Access Compliance Report

Public Rights-of-Way

(Curb Ramps)

Intersection ID: 5407	Main Street: J_W_CLAY_BV	Cross Street: J_M_KEYNES_DR	Location: E
ADA ID: D8CE2E6825D9	Ramp Type: Perp	Initial Pass/Fail: Fail	Overall Compliance: No
Severity Score: 12.5			
Codes/Mitigation Info/Possible Solution		Field Measurements/Component Compliance

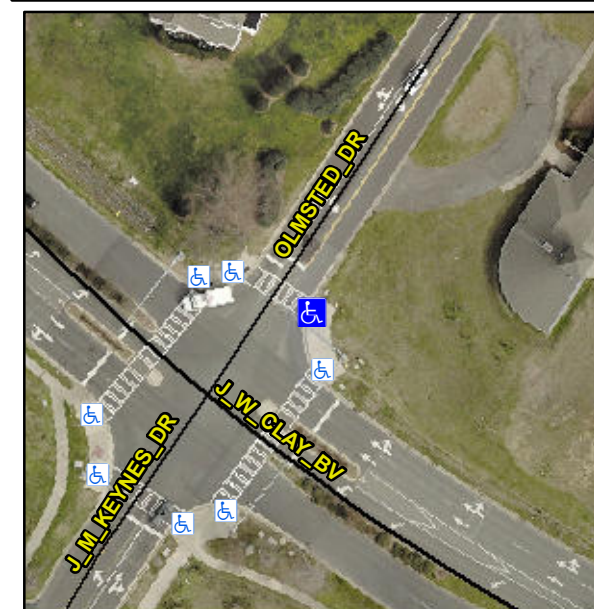
R304.2.2

Remove & Replace Entire Ramp.
